Accessibility Survey

City of Downey Rutgers Avenue - Angell Street To Foster Road

Date of Inspection 12/3/2016

Top Landing

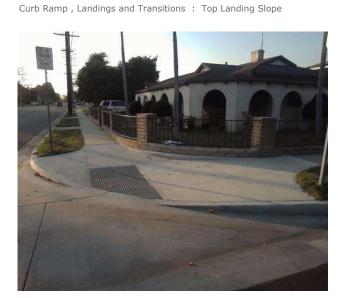
Finding

The slope at the top landing is greater than allowed.

On-Site Finding 2.70 percent

Recommendation

Provide a top landing surface that does not exceed the maximum slope and cross slope. Provide a sufficient maneuvering clearance that does not accumulate water.

Recommendation Up to 2.08 percent

Bottom Landing

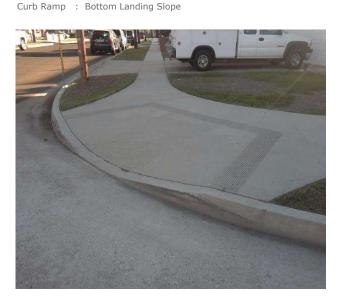
Finding

The bottom landing of the curb ramp is on the street, and the slope of the bottom landing is not compliant.

On-Site Finding 7.30 percent

Recommendation

Ensure the bottom landing slope is compliant and provides a smooth transition.

Recommendation Up to 5.00 percent
